Access Compliance Report

Public Rights-of-Way

(Curb Ramps)

Intersection ID: 46732	Main Street: DARCY_HOPKINS_DR	Cross Street: THREATT_WOODS_DR	Location: NW
ADA ID: 8A4370FC7B38	Ramp Type: PerpDiag	Initial Pass/Fail: Fail	Overall Compliance: No
		Severity Score: 10

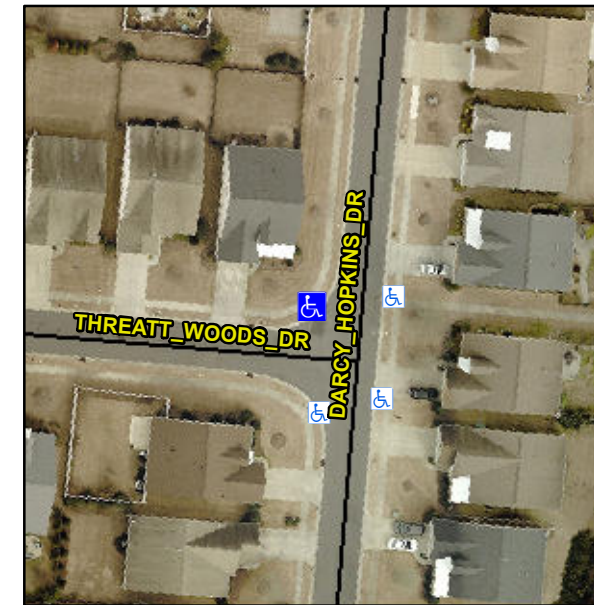
Not Found, R304.5.1, R304.5.3

Compliance	Description	Data	Compliance	Description	Data
N/A	Ramp Length (in)	50.0	Yes	Ramp Slope (%)	5.1
No	Ramp Width (in)	42.0	No	Ramp XSlope (%)	3.1
N/A	Flare Type LT	N/A	N/A	Flare Type RT	N/A
N/A	Flare Slope LT (%)	N/A	N/A	Flare Slope RT (%)	N/A
N/A	Flare Traversable LT?	N/A	N/A	Flare Traversable RT?	N/A
N/A	Landing Length (in)	N/A	N/A	DWS Provided?	N/A
N/A	Landing Width (in)	N/A	N/A	DWS Contrast?	N/A
N/A	Landing Slope (%)	N/A	N/A	DWS Length (in)	N/A
N/A	Landing X Slope (%)	N/A	N/A	DWS Full Width?	N/A
N/A	Landing Curb? (Y/N)	N/A	N/A	DWS Offset (in)	N/A
N/A	Shared Landing?	N/A			
N/A	Gutter Ponding?	N/A	N/A	Gutter Slope (%)	N/A
N/A	Gutter Lip Ht (in)	N/A	N/A	Gutter X Slope (%)	N/A
N/A	Painted X Walk1?	No	N/A	Painted X Walk2?	No
	X Walk 1 Direction	To SW		X Walk 2 Direction	To SE
N/A	X Walk 1 Width (in)	N/A	N/A	X Walk 2 Width (in)	N/A
	X Walk 1 Slope (%)	1.2		X Walk 2 Slope (%)	0.2
	X Walk 1 X Slope (%)	0.9		X Walk 2 X Slope (%)	1.4

Remove & Replace Curb Ramp With Two New Directional Ramps or Equivalent.
